# *Service Bulletin*

**Model :** **GP160F**

**No.:** GP160-004
(FF-T01-E40-000037-01)

**Subject :** **Parts addition**

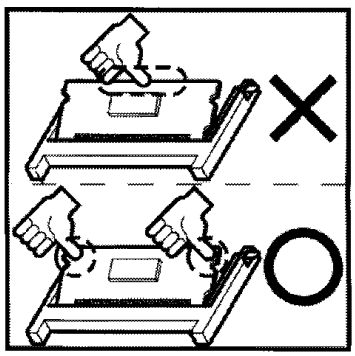
If the centre of the DIMM is pressed when the DIMM is inserted, some of the IC chip pins may not go in fully.

Seals warning the user to press down on both ends, and not in the middle,will be stuck on at the two locations described below:

1. On the accessory DIMM package.
2. On the service parts FLASH ROM PCB ASSEMBLY package.
